# **Bureau of Environmental Health**

RECEIPT	DATE: 5/12/2020 ONSITE SEWAGE DISPOSAL SYSTEM P 567391
APPROVAL	DATE: PERMIT: CONSTRUCTION
PROPERTY A	DDRESS: 1032 STEPPING PLACE, SYKESVILLE, MD 21784
	WALKER MEADOWS   LOT: _21   TAX ID: 03-601579
CONTRACTO	R: SOUTH CARROLL BACKHOE, INC. EMAIL:
	ADDRESS: 4410 SALEM BOTTOM ROAD, WESTMINSTER, MD 21157 PHONE: (410)875-4197
	WNER: NVR, INC. EMAIL: janastas@nvrinc.com
OWNER ADDR	ESS: 9720 PATUXENT WOODS DRIVE, COLUMBIA, MD 21046 PHONE: (410)379-5956
	IZE (GALLONS): 2000 TANK MANUFACTURER: Babylon Vault
PUMP MODEL	PUMP SIZE n.a. PUMP TANK CAPACITY: n.a.
	The state of the s
DISTRIBUTION	N SYSTEM: GRAVITY PRESSURE DOSED BEDROOMS: 6 APPLICATION RATE: 1.2
	LINEAR FEET REQUIRED: 168 INLET DEPTH: 2.0
TRENCHES:	TRENCH WIDTH: 2 MAXIMUM BOTTOM DEPTH: 6.0
	MINIMUM SPACE
LOCATION	PER APPROVED SITE PLAN. SEWAGE DISPOSAL AREA AND TANK LOCATIONS MUST BE STAKED BY LICENSED
LOCATION:	SURVEYOR PRIOR TO PRE-CONSTRUCTION INSPECTION.

WALKER MEADOWS

LOT 21 ONSITE SEWAGE DISPOSAL SYSTEM DESIGN PLAN

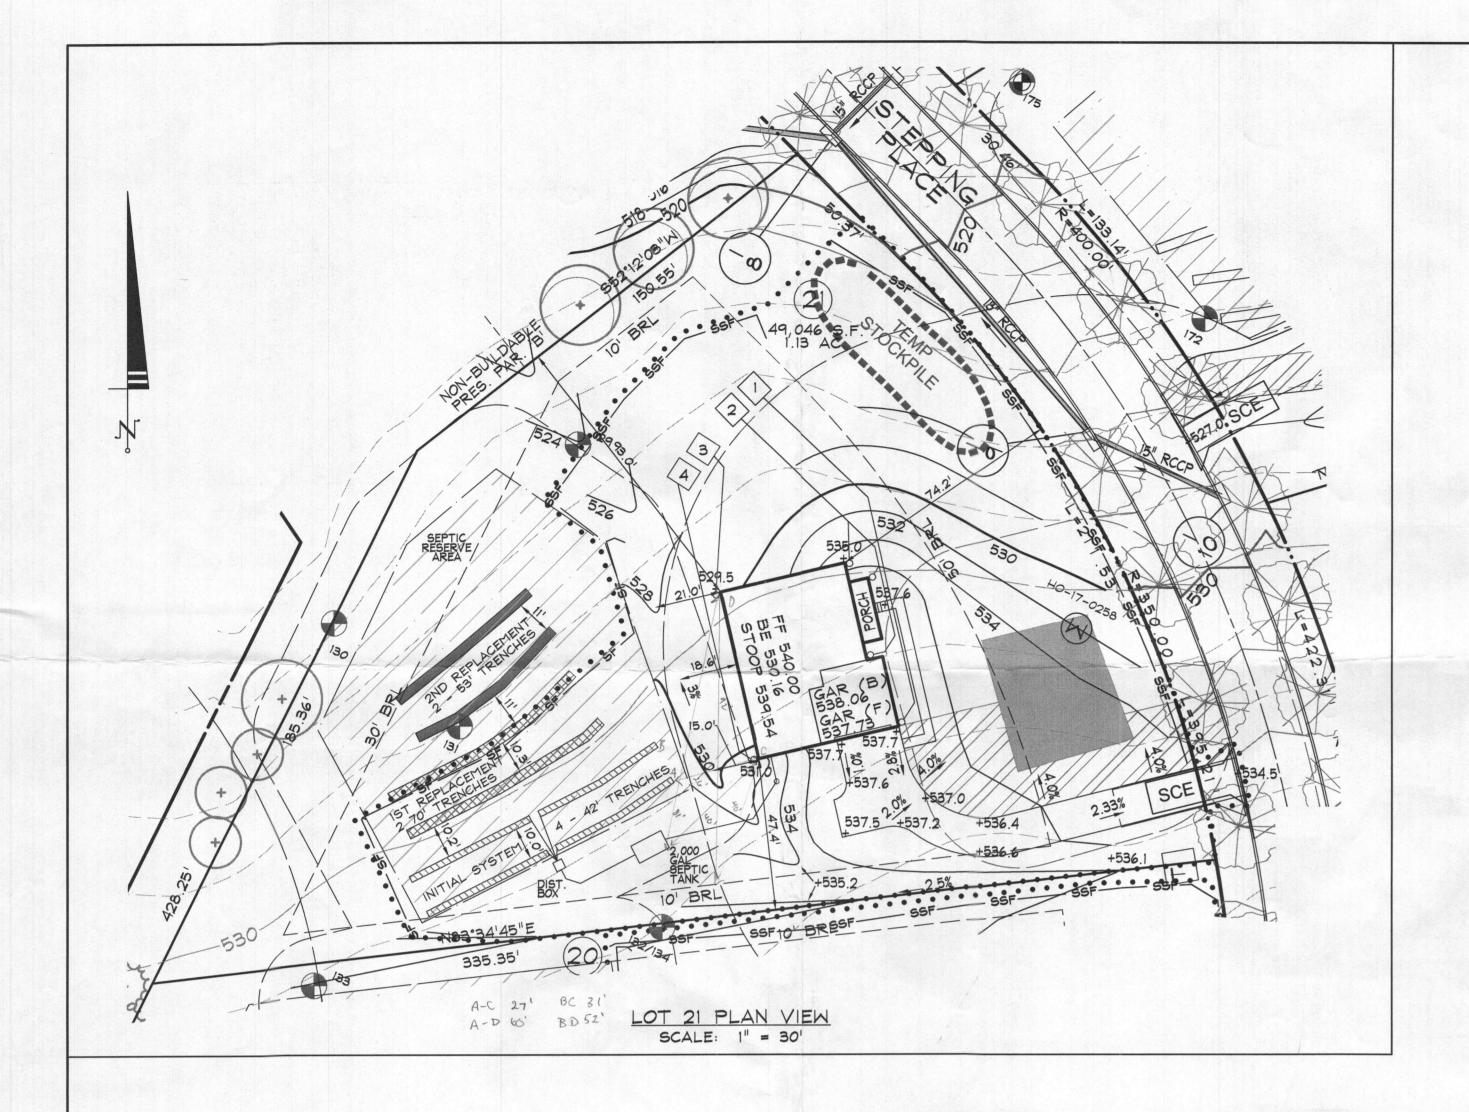
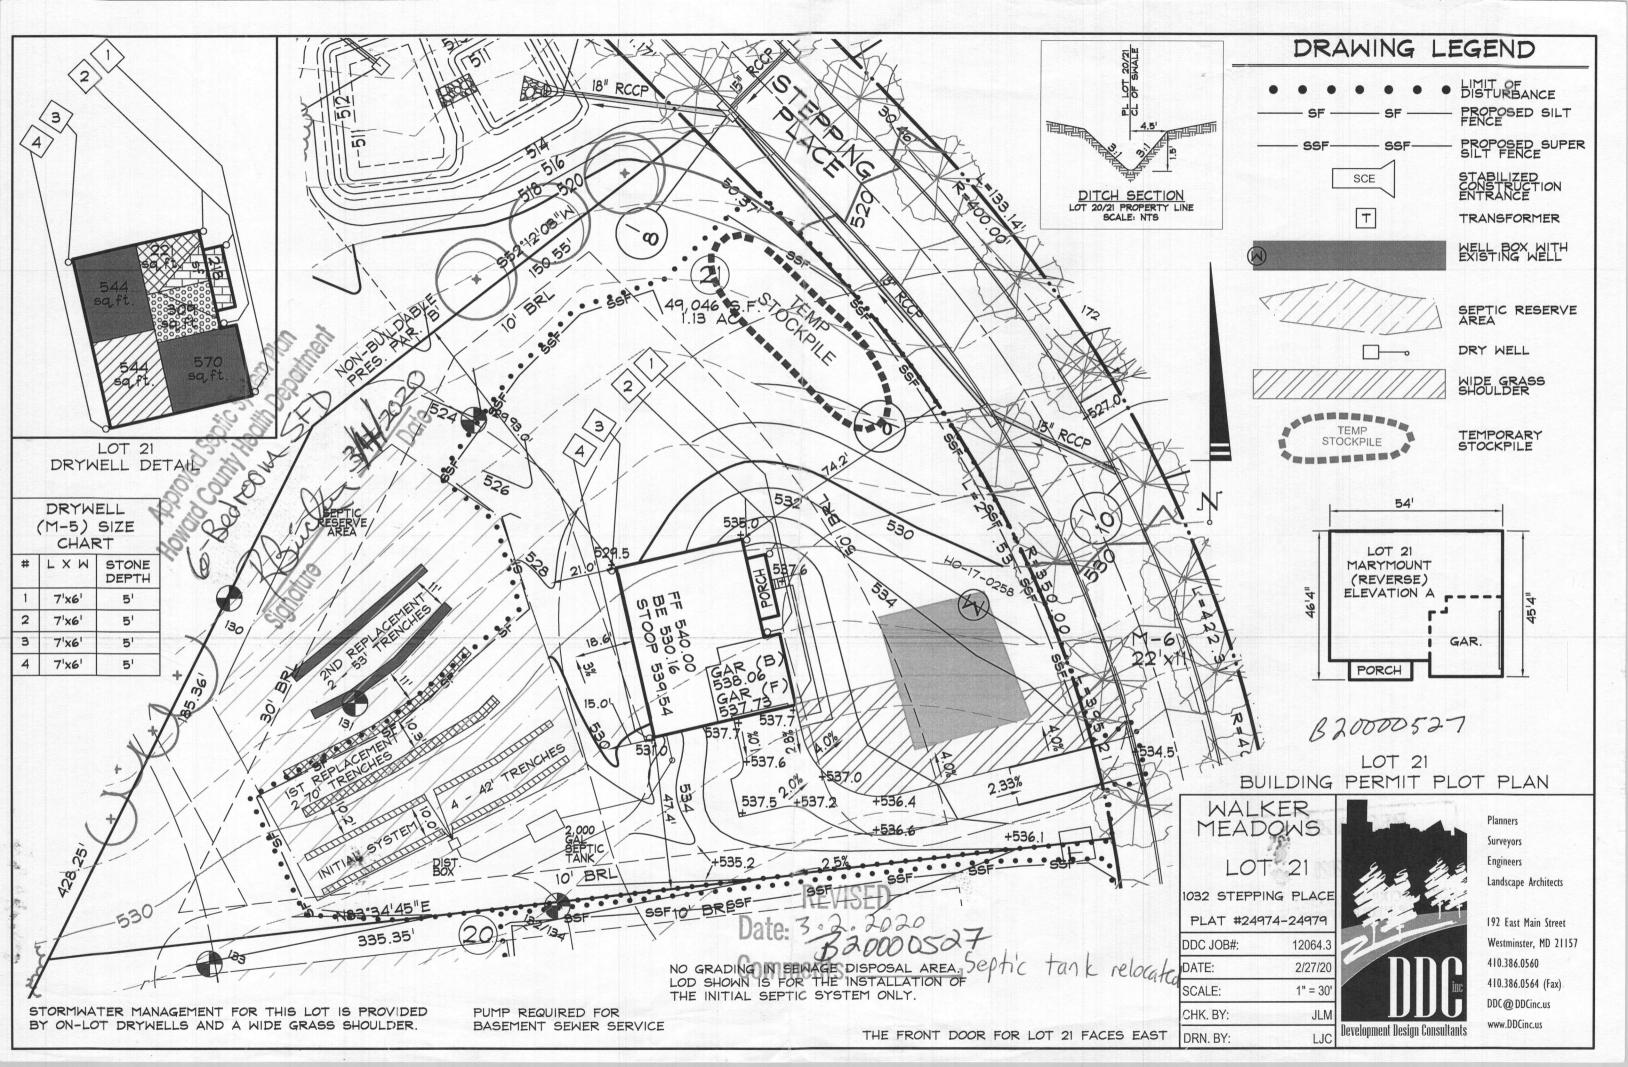
Stepping Place	TO THE PROPERTY OF THE PROPERT
216	House NOT TO SCALE 1"=  House 122' NOT TO SCALE 1"=  127' 125' 33' 35' 35' 35' 35' 35' 35' 35' 35' 3	TRENCH/DRAINFIELD DATA WIDTH INLET BOTTOM  2' 2' (6'    NUMBER OF TRENCHES 4
	ut tank and trenches acce	
SHE S 6/4/20 Yet, Abox levelers or to fackfill.	good stone looks good applicative to be	one trench complete. Reinspect for or k complete but SHC not done ic in place, other votion pipes in place.
FINAL INSPECTOR		ATE OF APPROVAL
